OFFICE OF THE
TOWN PLANNER

Re: TRC Variance Recommendations (Consent Agenda Items)

Re: Beauregard Subdivision - AP 44 Lot 180 - TRC Bond Recommendation

Wilbour Plat – Master & Preliminary Plan
TRC Report for the February 22, 2023 Planning Board Meeting

Proposed Conditions Plan (Sheet 2 of 3)

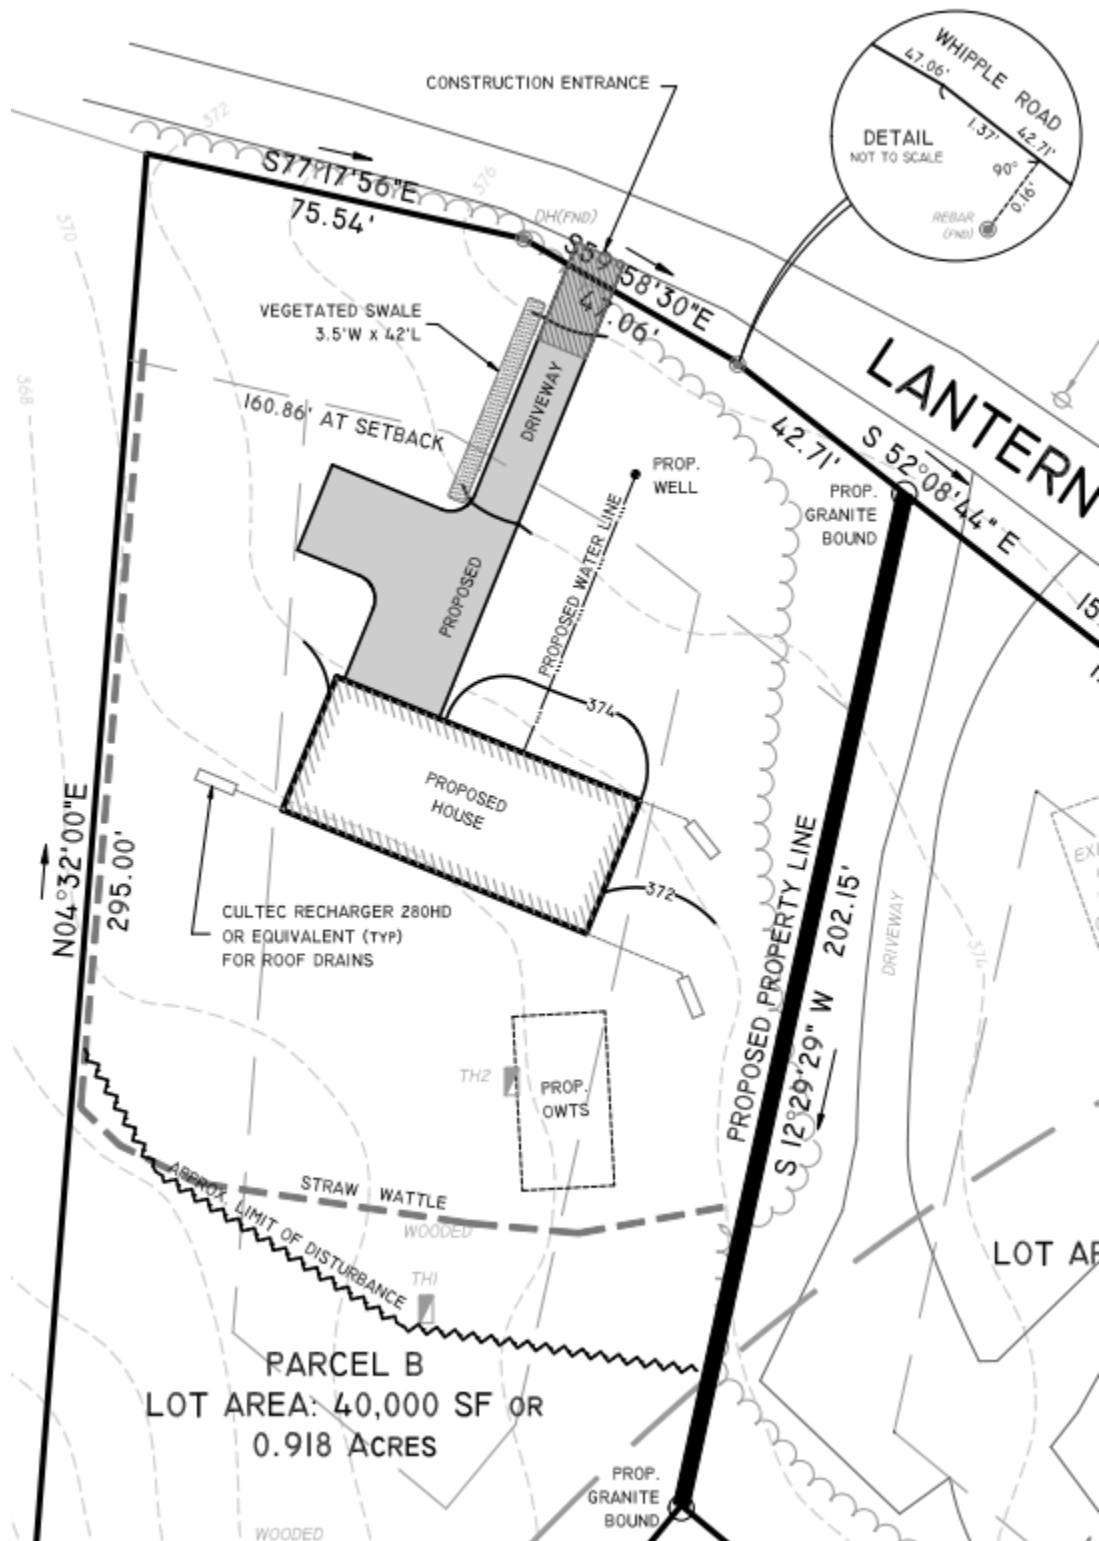
The proposed improvements for Parcel B are all in standard locations typically found in single-family development. The primary residence complies with all setbacks and has even been shown to be setback at a distance that is consistent with the closest abutting home to the west. The proposed well is between the residence and Lantern Road and the septic system is in the rear yard. The driveway is designed only wide enough for one car, so there is a turnaround space. The TRC noted that there is an existing stone wall that is not shown on the plans. The TRC believes that the existing driveway location is where the gap in the wall exists, but due to the lack of wall on the plans, recommends a condition that the driveway be located as to not disturb the stonewall.

The applicant proposes private well water and septic for the new lot. The existing home has well and septic. The applicant provided a water table verification as required by the preliminary plan checklist for the septic system. The Town engineer recommended a condition that the OWTS/ISDS permit be obtained prior to approval of the Final Plan.

The Town Engineer has reviewed the stormwater and drainage patterns and recommends that the final review of drainage be conducted as part of the building permit review process.

1. The driveway for Parcel B shall be located as to eliminate or minimize disturbance to the existing stone wall.
2. Obtain an OWTS/ISDS approval prior to Final Plan approval.
3. Final review of drainage for Parcel B will be reviewed at the building permit phase.
